City of Plymouth Planning Commission Special Meeting Agenda Wednesday, October 27, 2021 – 7:00 p.m. ONLINE Zoom Webinar

**Site Plan Review
For
Plymouth, Michigan**

Subject: Response to Review Comments
Plan Review
1115 S. Main Street
6/25/2021

RE: E.G. Nicks – Revised Site Plan Materials

1 OVERALL RESTAURANT PLAN - E.G. NICK'S
AS1 3/16" = 1'-0"

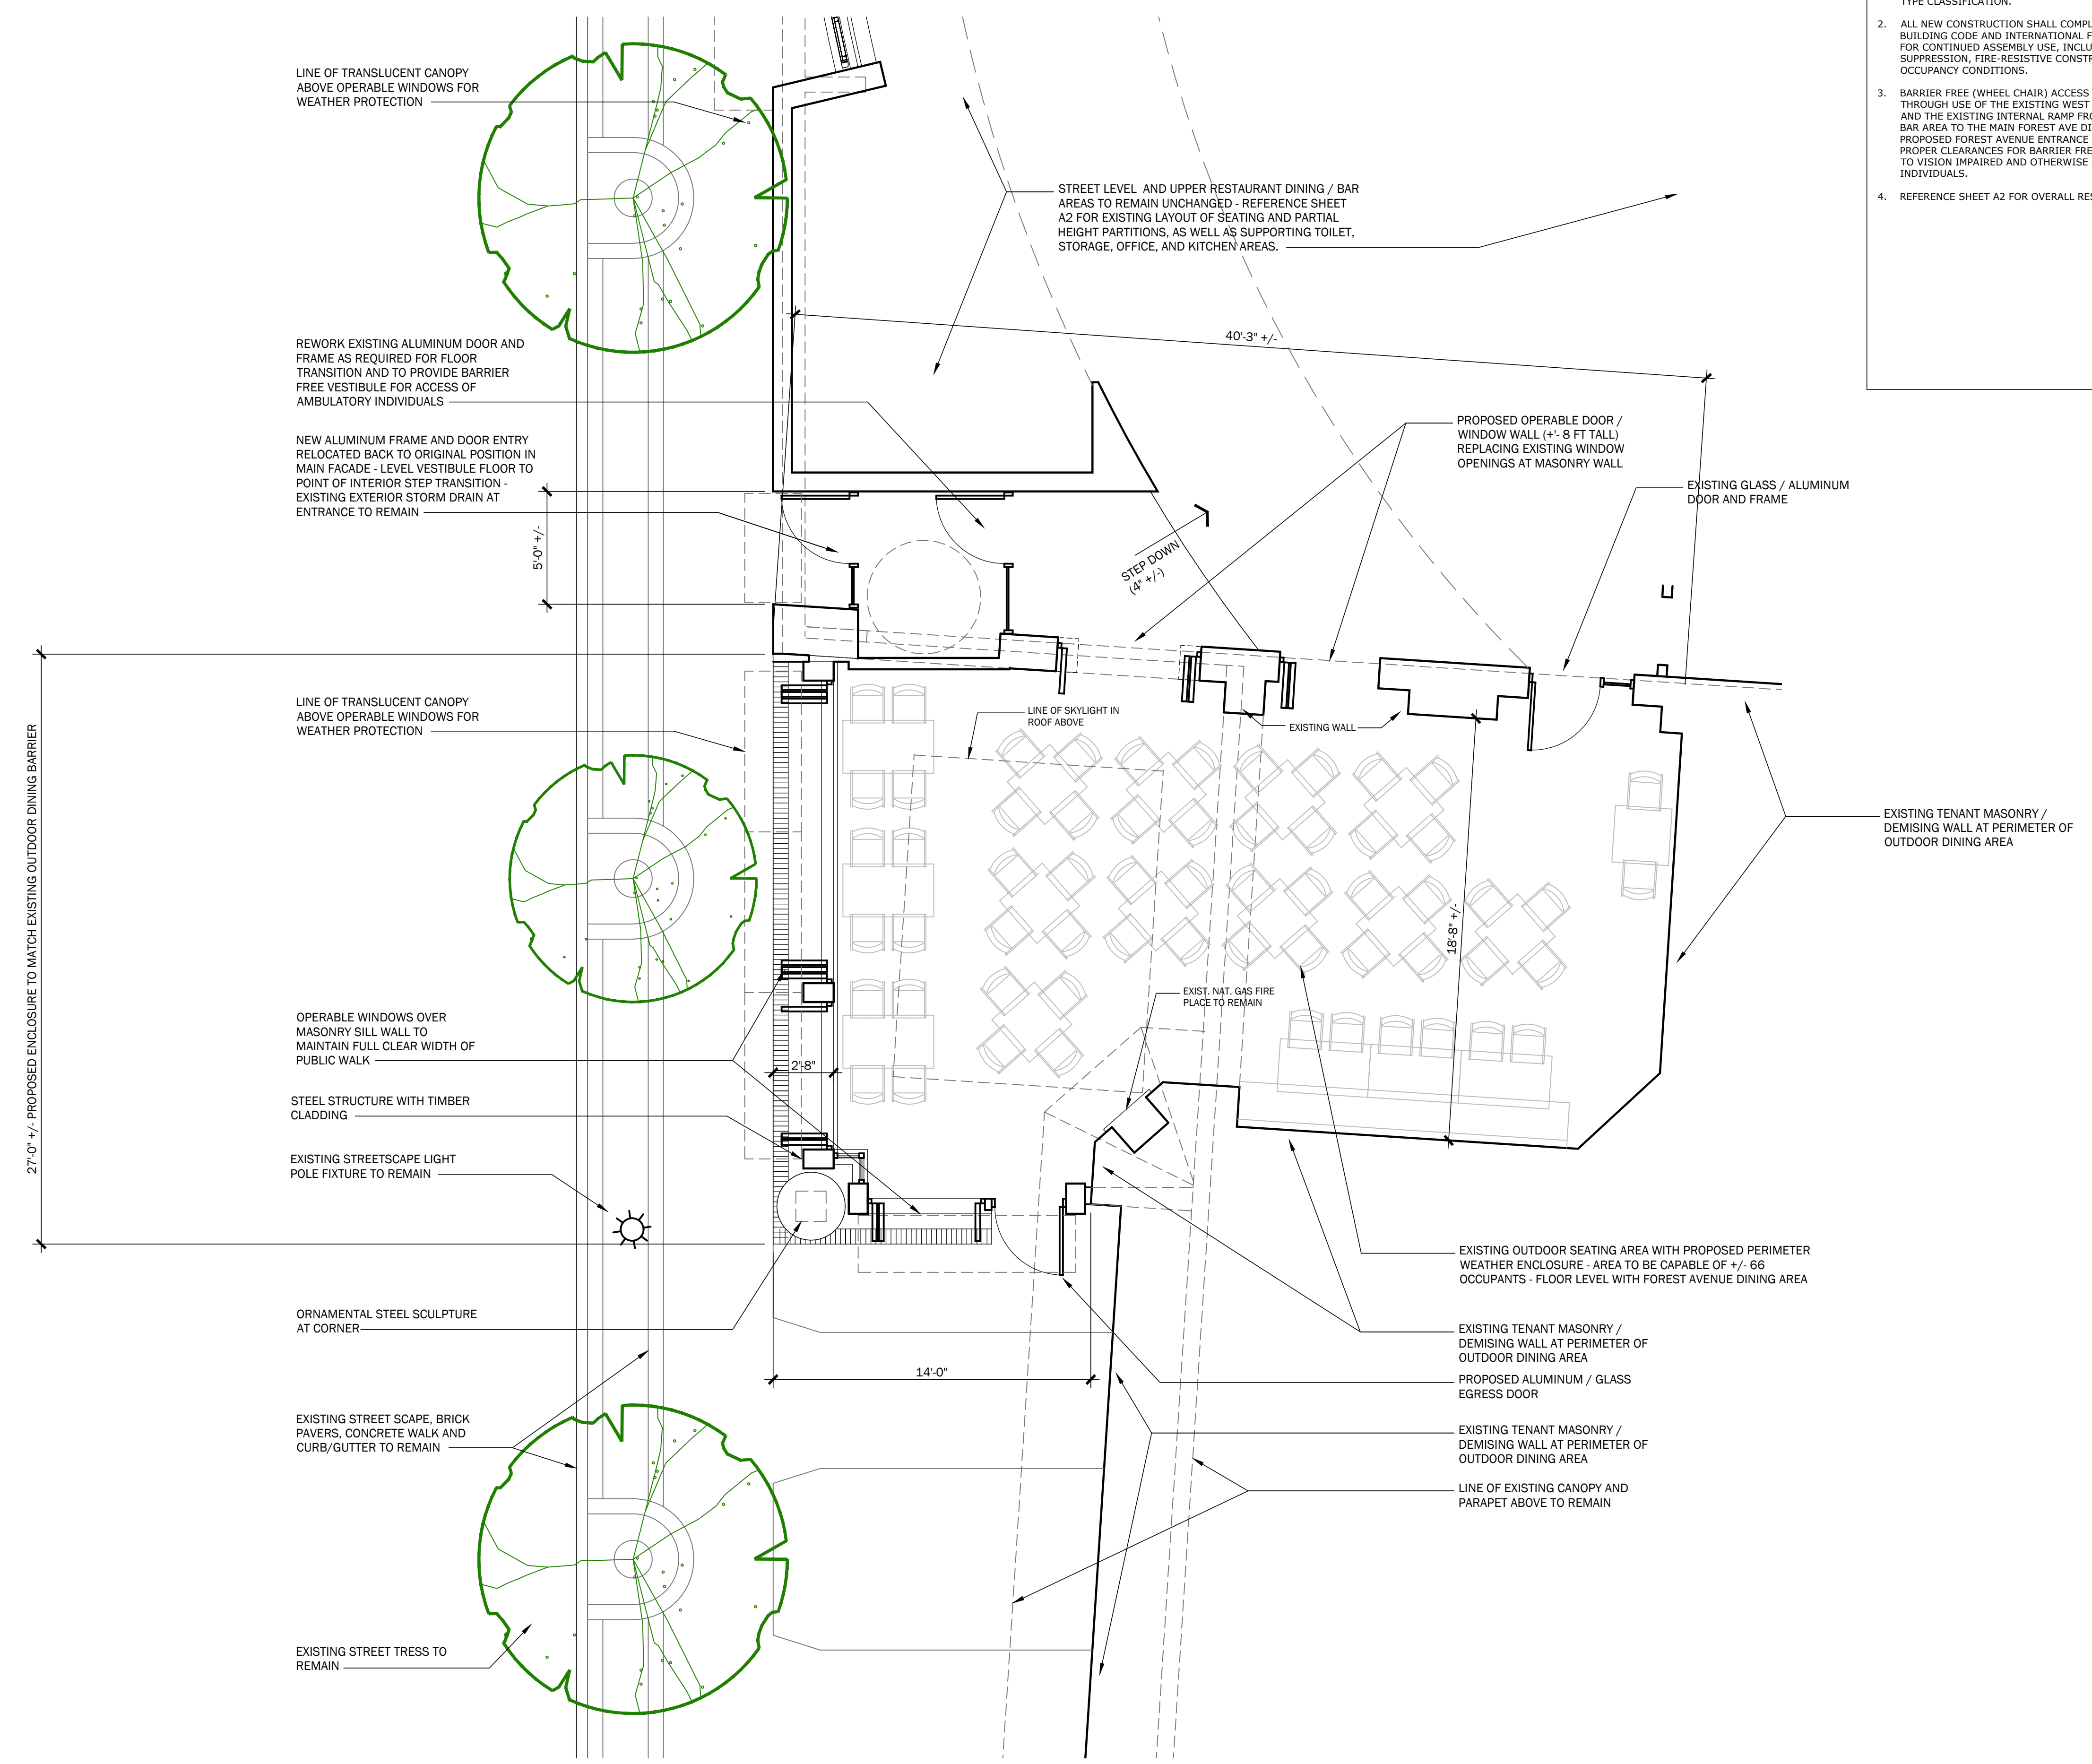
4. Add two more barrier-free parking spaces to the existing lot on the plans.

5. Identify where loading/unloading occurs for this site on the plans.

7. Provide a detail of the dumpster screen on the plans.

The revised Site Plan and Parking Counts sheet (Sheet AS1) shows two new barrier-free parking spaces just to the west of the rear entrance to the restaurant. The rear entrance is also the barrier-free entrance. The location of these spaces is logical. The dimensions of the spaces, and aisle, also meet ordinance requirements. Note that the Building Official will confirm that the barrier-free spaces striped in the lot meet the dimensional requirements.

Sheet AS1 shows the existing loading/unloading space directly behind the restaurant. The location is logical, and keeps the loading activities out of the travel lanes and parking spaces. The dimensions of the space meet the ordinance requirements.

A note and line sketch of a dumpster screen have been added to the site plan. The note states that a screen will be added upon review by the property owner and City for compliance with the zoning ordinance.

- Item 2: Loading / Unloading Space** - The attached site plan Sheet AS1 has included the existing area used for loading/unloading, capable of supporting the typical 10 ft X 50 ft required space.

PROPOSED
ELEVATIONS
FOREST AVENUE

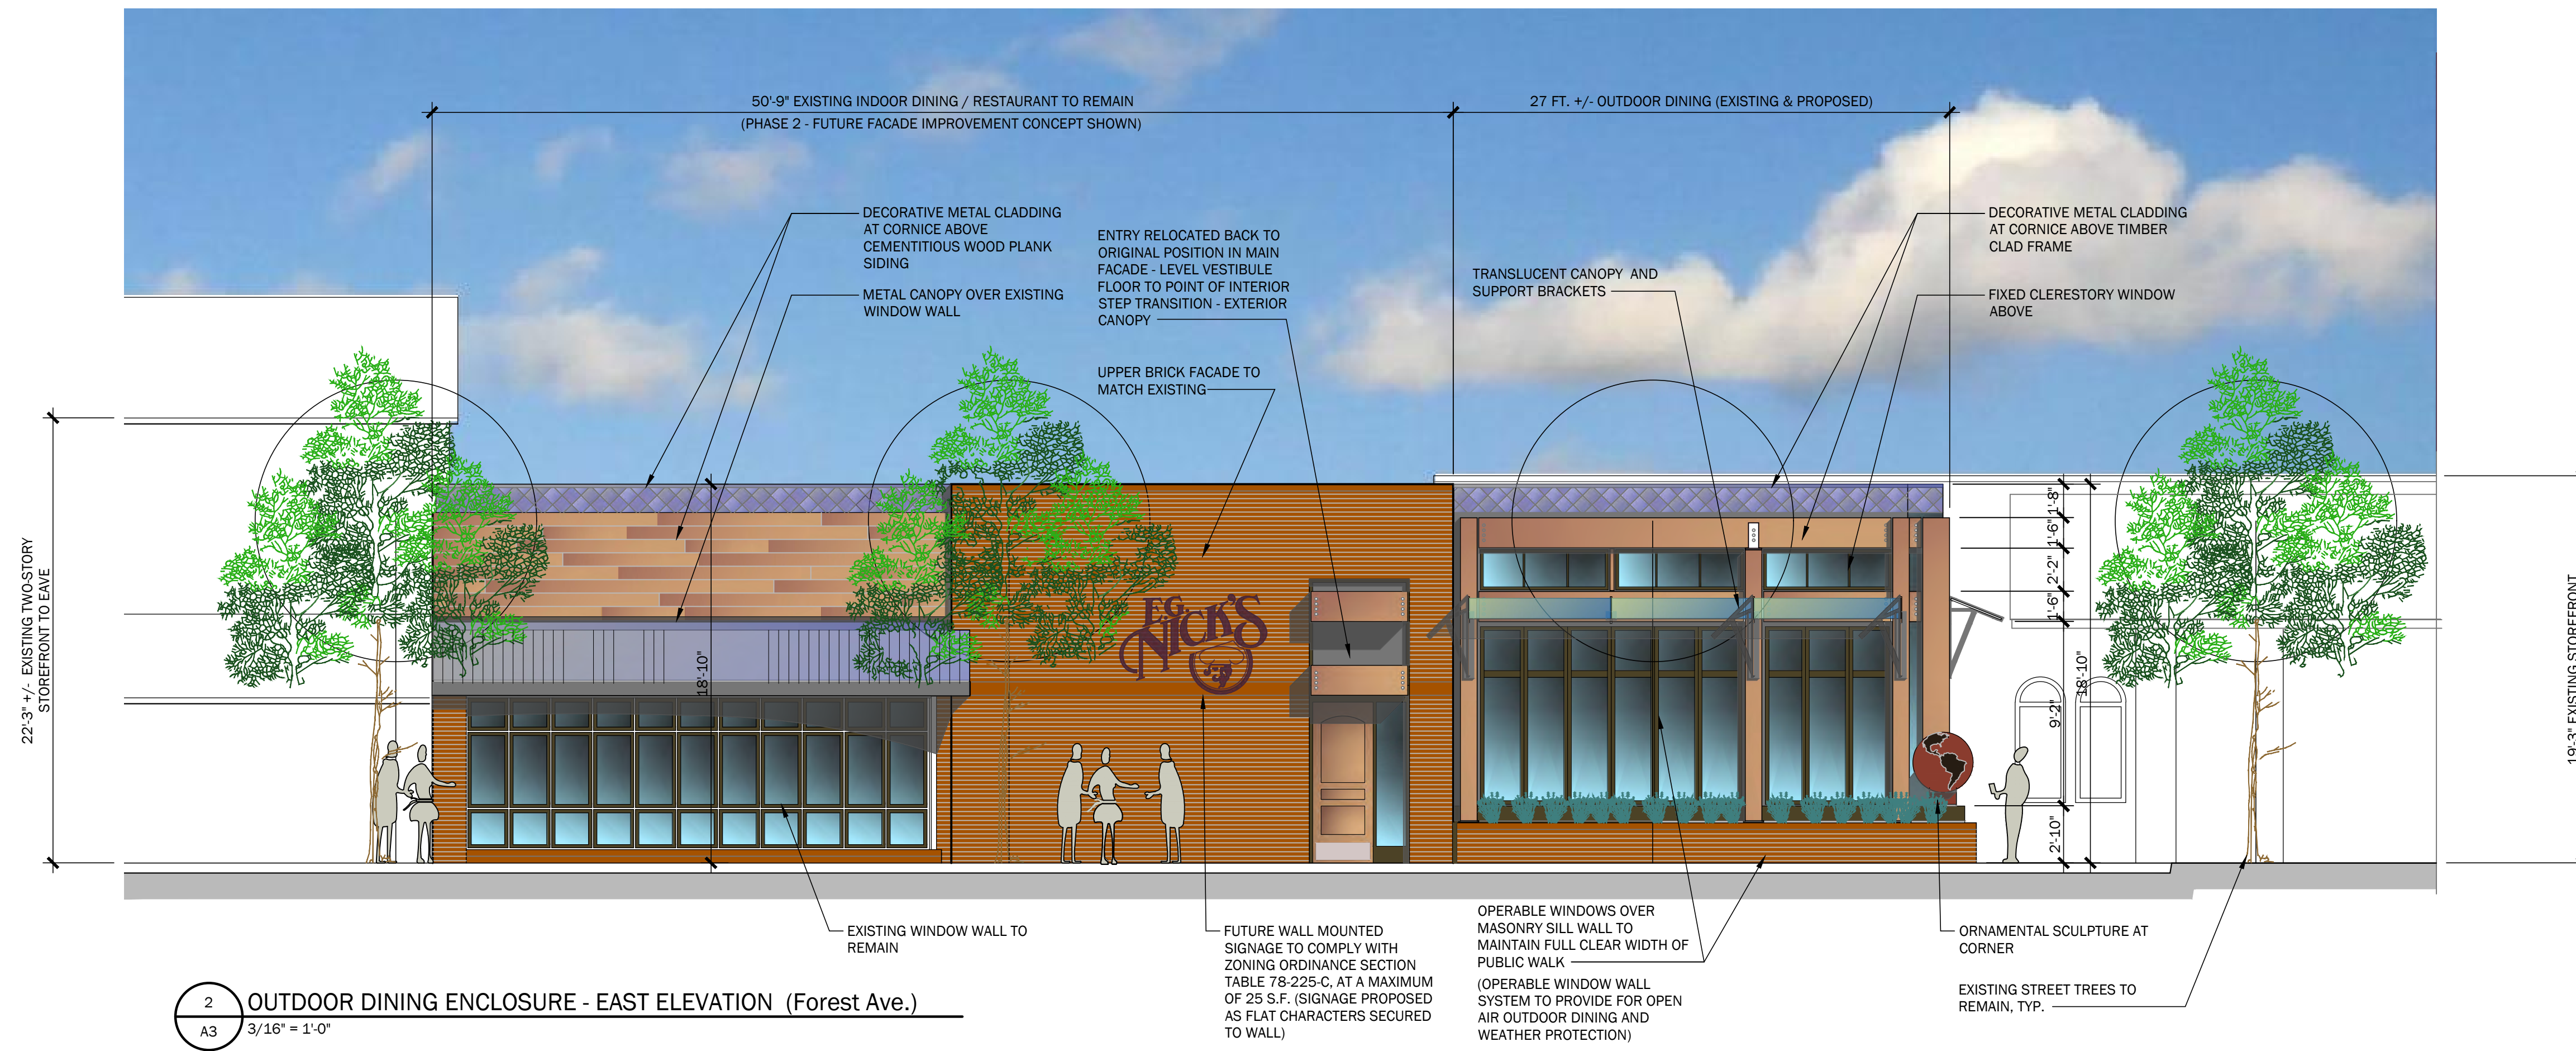
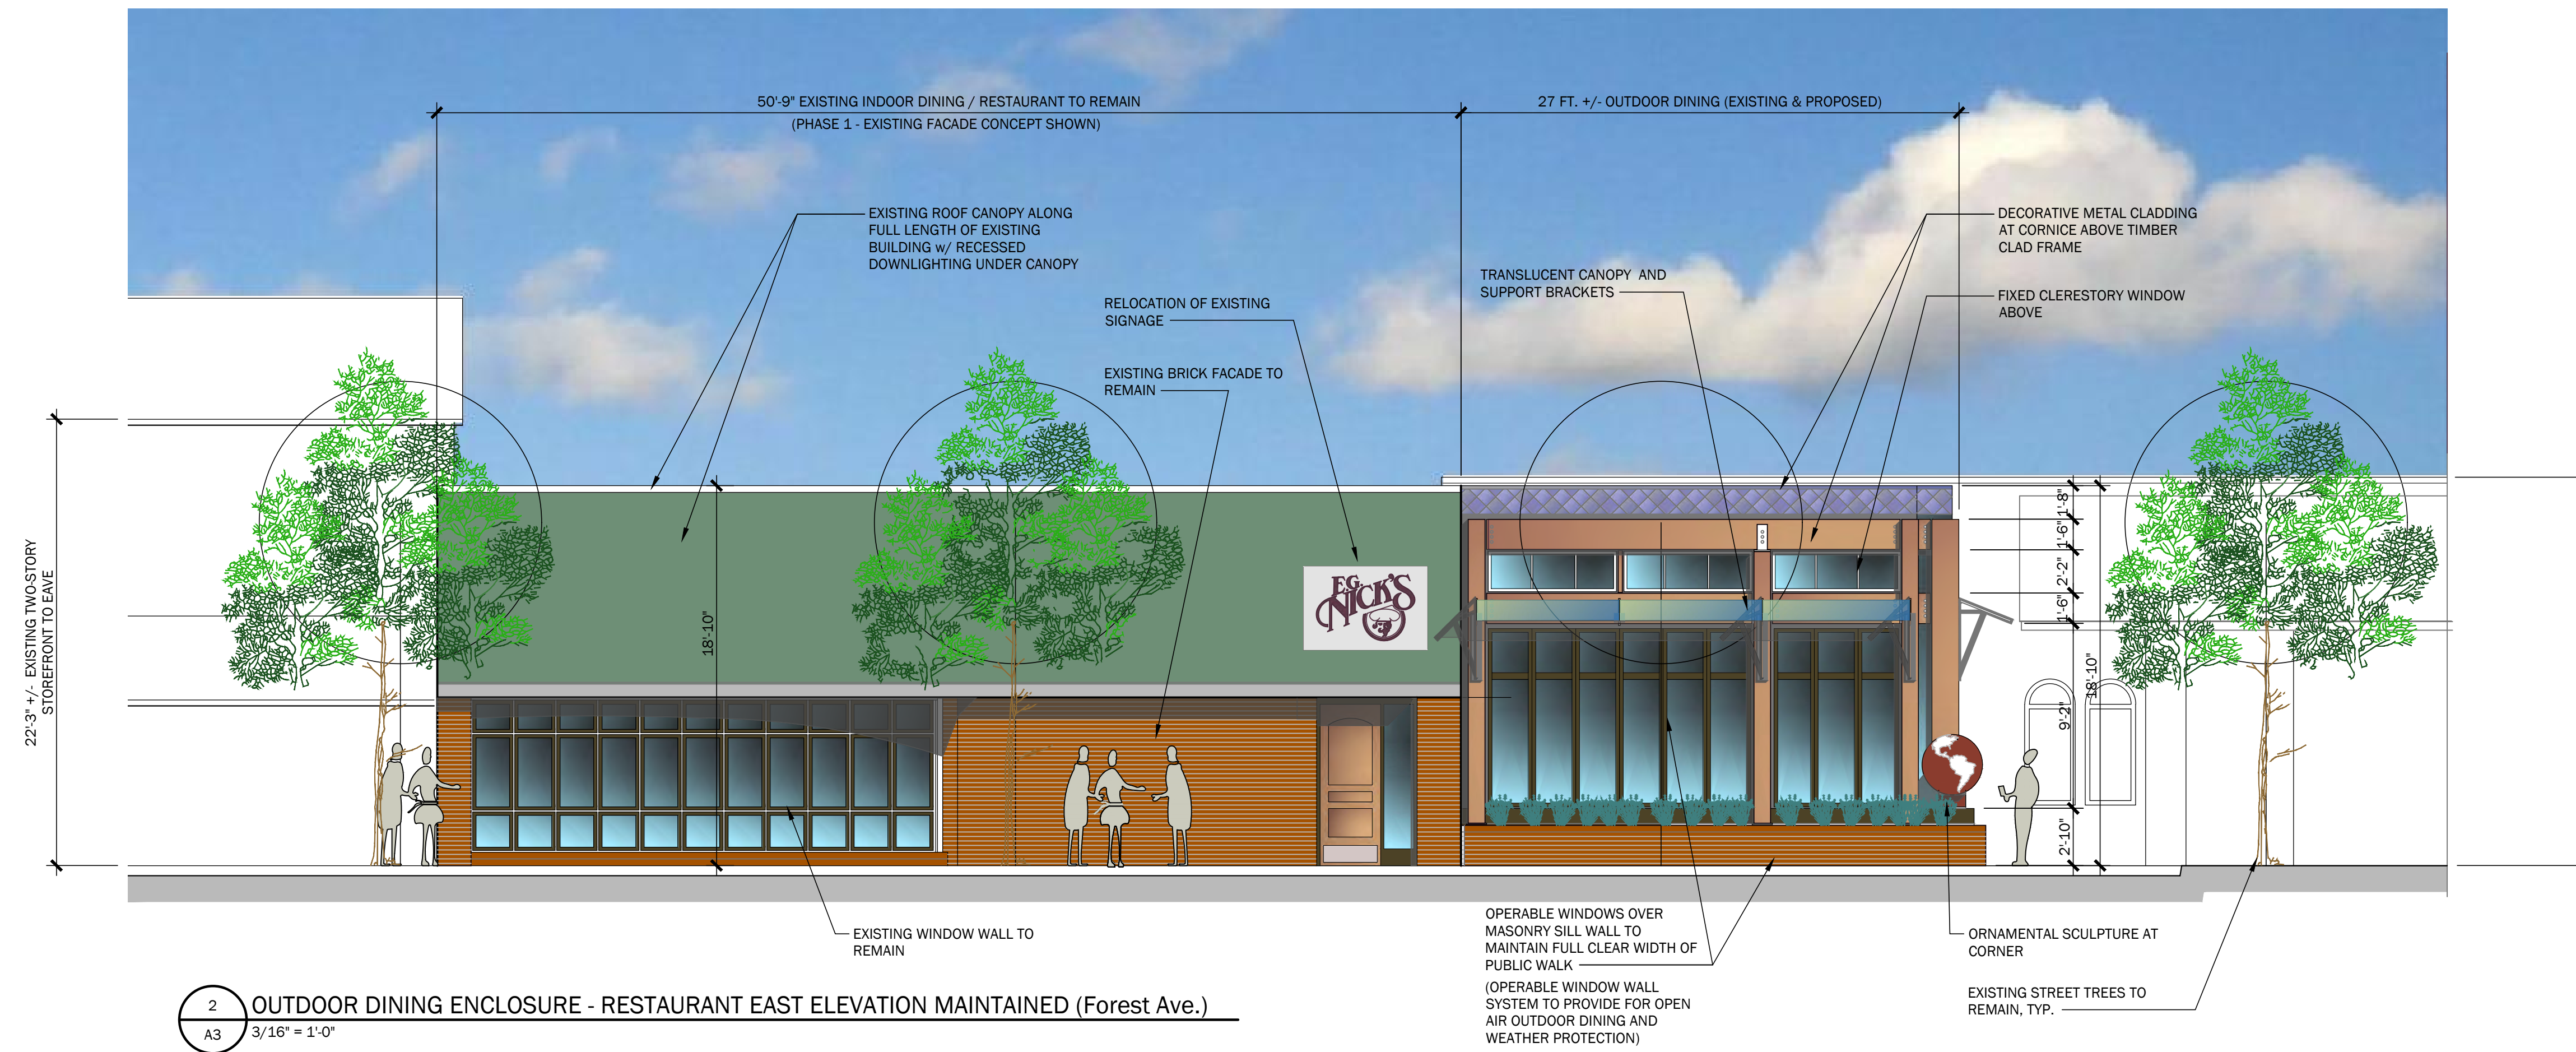
2. Provide sign information, if applicable.

3. Provide building elevation drawings.

The revised elevation drawing (Sheet A3.1) shows that the existing sign will be relocated over the new pedestrian entry door on the east façade of the building. If a new sign is proposed in the future, the applicant will be required to obtain a Sign Permit, at which time conformance with the zoning ordinance will be evaluated.

Building elevations have been provided that show the new enclosed area. An additional drawing (Sheet A3) also shows "future" renovations to the front façade of this restaurant, as well as the business space to the south. Building elevation design, outside of health and safety issues, is not within the purview of the Planning Commission, and the Building Official will review these changes upon application for a building permit.
